: CU-DAR001 Dart Helicopters Services **Drawing Name** : AFT BASE ASS'Y Job Number : 39931 -1 Estimate Number : 13043 P.O. Number Part Number D3651041 This Issue : 18/06/2008 S.O. No. : **Drawing Number D3651 REV.B** Prsht Rev. : NC Project Number First Issue : // : B Type **Drawing Revision** : 36913 Previous Run Material Written By Due Date : 07/07/2008 Each Checked & Approved By Comment : Est Rev:A D verified by: EC ECN 1113P 3841-22 DD verofoed by: EC Est Rev:C ecn1162 38-34-32 DD verified by: EC Additional Product Job Number Machine Or Operation: Seq. #: Description: 1.0 PACKAGING 1 **PACKAGING RESOURCE #1** Comment: PACKAGING RESOURCE #1 Pick Packing Kit 2.0 D3651043 Pange Weldment Comment: Qty.: 1.0000 Each(s)/Unit 2,0000 Each(s) N.P FLANGE ASSEMBLY 39435-1 D36511 9.4 Comment: Qty.: 1.0000 Each(s)/Unit 2 00000 Each(s) GASKET 4.0 D36519 side Doubler N.P Comment: Qty.: 1.0000 Each(s)/Unit Total >, 2.0000 Each(s) DOUBLER D365111 8.4 Comment: Qty.: 1.0000 Each(s)/Unit Total: 2.0000 Each(s) 39933 GASKET

D3651-041 AFT BASE ASSEMBLY

Subject: RE: Non-conforming D3651-041

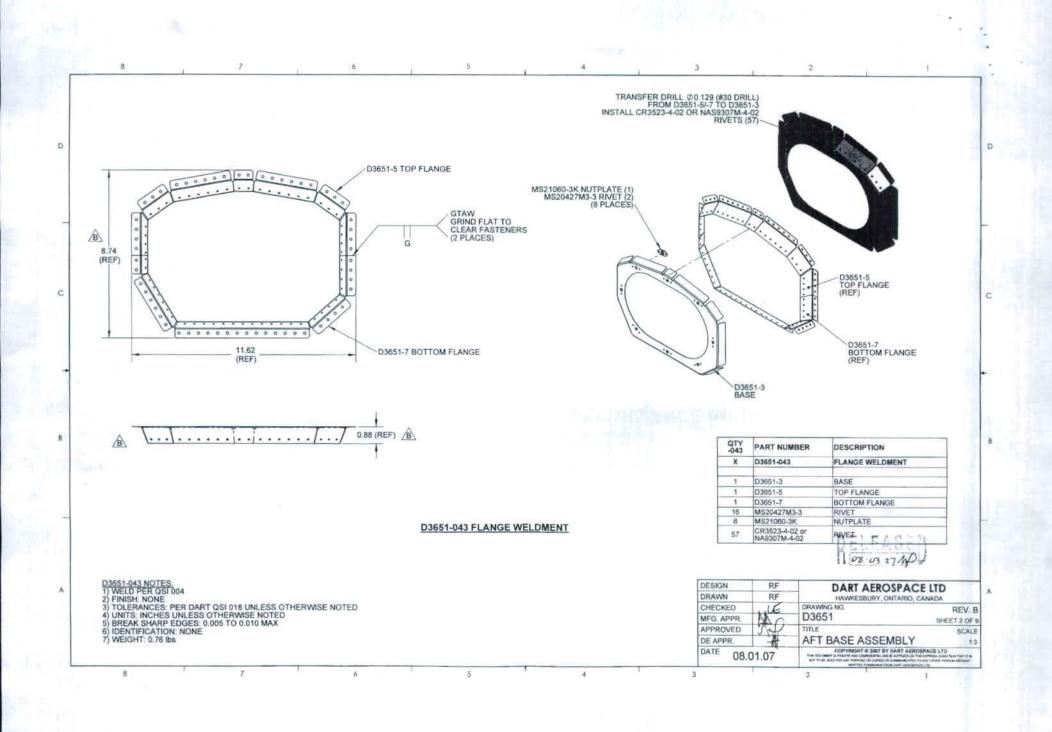
NCR: 39	731	W	ORK OR	DER NON-CONFORMANC	E (NCR)			
		Description of NC Corrective Action Section B					Approval	Approval
DATE STEP		Section A	Initial Action Description Chief Eng Chief Eng		Sign & Section C		Chief Eng	Approval QC Inspector
08/07/21	470	Durring Assembly it was noticed that the fell Assembly was more Assembled invertely: Hit the D3651-11 /D3651-13 Was installed with CR3532-4-01 Rints not CR3532-4-02 and the Prosent 700 was not put in place. R.C. employee assembles on who 39935 R and followed the D3651-1 Diag not the -out was also mose dellar inspection	OBOLT.	Parts are accatable or per David Shephards E-moul attache to the Bock: [Botween Marc B. AND DAVIDS July 23, ne. 2008) INSTALL Prografices per B# MC6294	\$ 00.0 08-07-50	5 8/2/30 S 8/2/30 S 8/2/30	13 OB 04 05	06/19/23 06/19/23 06/19/23

- 1) Drawing says to seal all mating surfaces and gaps using Proseal 700 Fire Wall Sealant: that did not happen and all parts are riveted;
 - Drawing says to use CR3523-4-02 Rivets to fasten D3653-043/-11/-13: the rivets used were CR3532-4-01 Rivets;
 - 3) If Items 1 and 2 above are acceptable deviations, is GA required to apply a bead of Proseal 700 all around the inside perimeter of the assembly (where D3651-043 and D3651-11) to ensure all gaps are sealed?
 - 4) Quantity of non-conforming parts: 1.

With respect to the rivets, the length change is insignificant. If the rivets pulled up properly, then you can sign this off as a deviation. If the -01 are better than -02, we should change the drawing. This is surprising since we've already made these before ...

With respect to the sealing issue, the intent is that we seal mating surfaces when there is metal to metal contact. Where there is a gasket between two pieces of metal, then I don't think we need sealant. Any air gaps in the assembly should be plugged with sealant after rivetting
